ADDENDUM 1

Project: Innis Road Apartments

Addendum Issue Date: September 8, 2026

Architect of Record: The Columbus Design Co.

C200

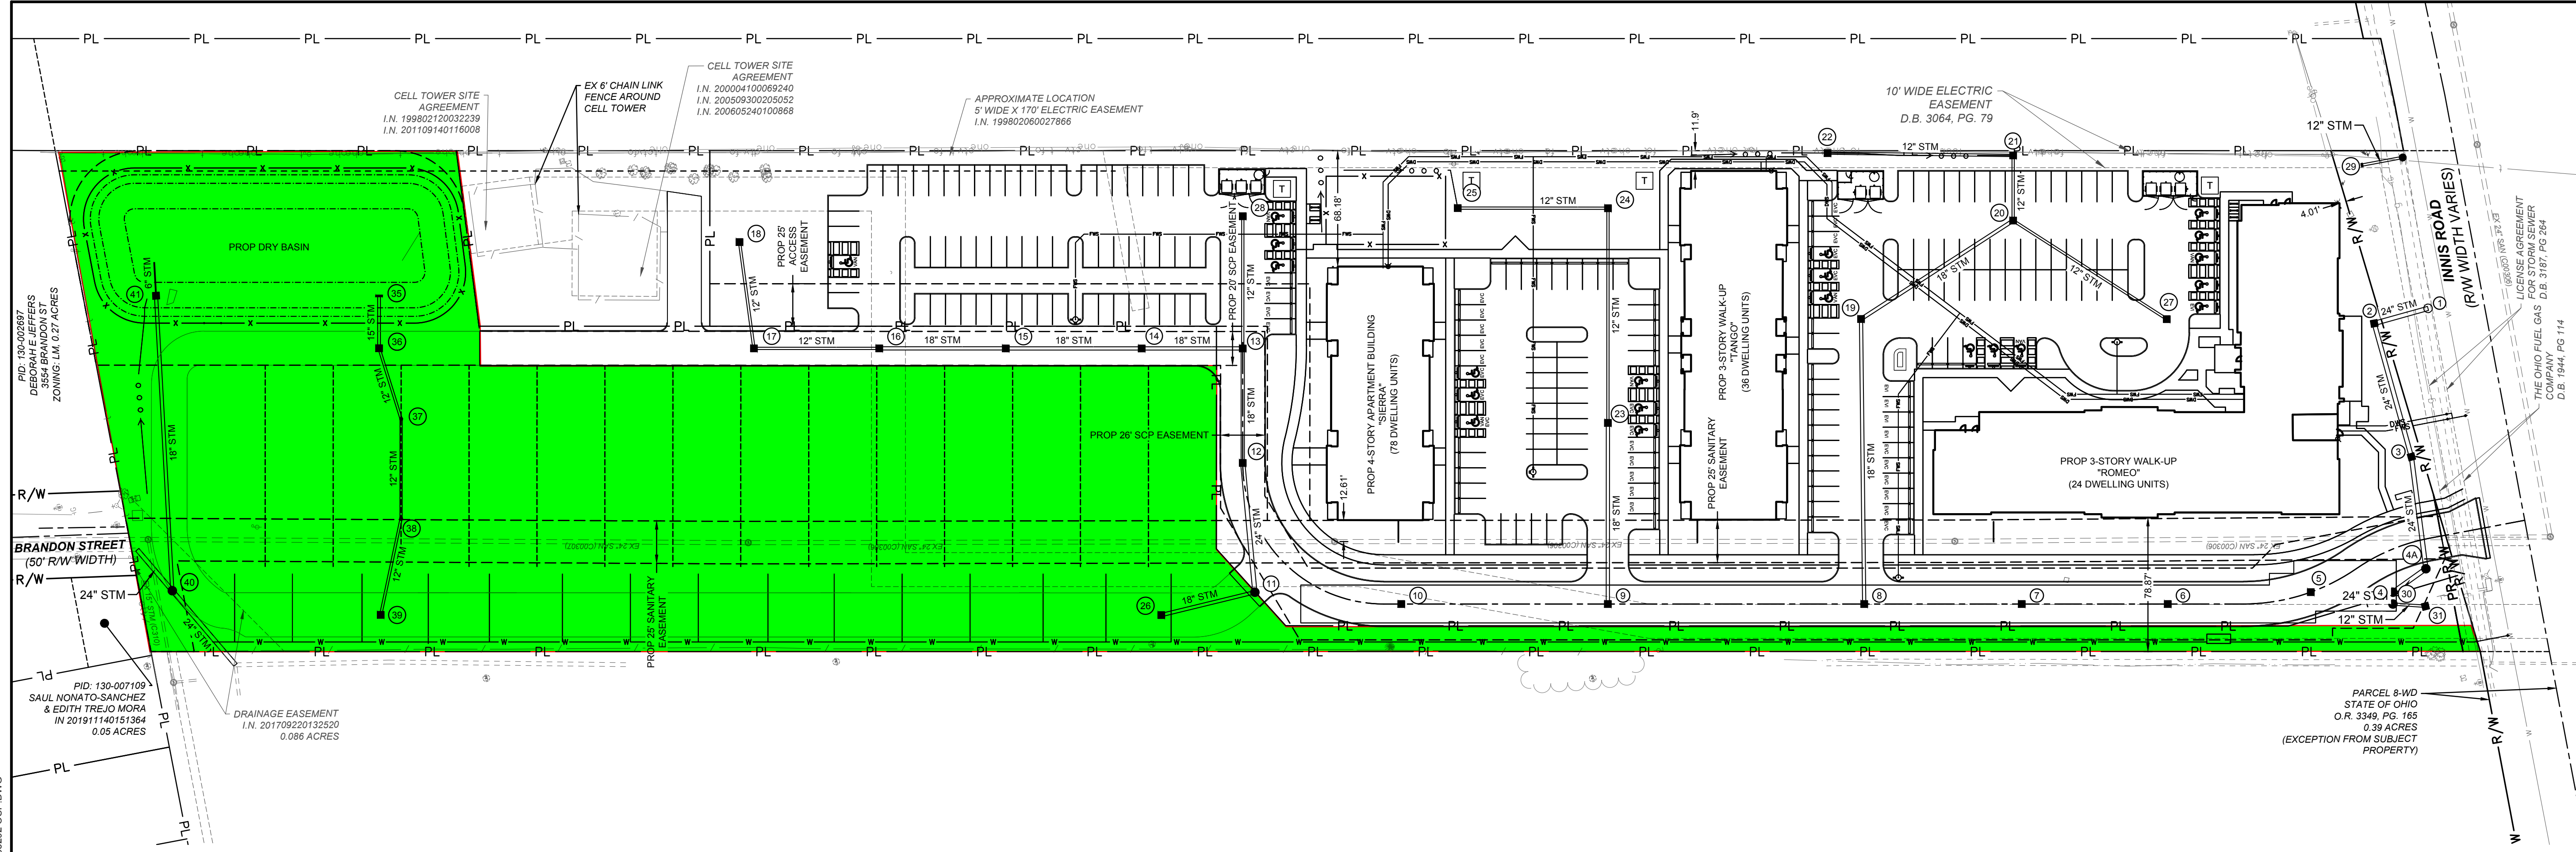
For accounting purposes, please separate the cost of the Green highlighted areas (i.e. Grading, Site Water, Site Storm, Asphalt, Fencing)

1. Proposals for **BP 31A Site Work** and **BP 32A Asphalt Paving** shall separate the cost related to the Future Houses. See drawing "Innis Road Apartments – Site Breakout Pricing" for extents. Breakout pricing will be used for accounting purposes.
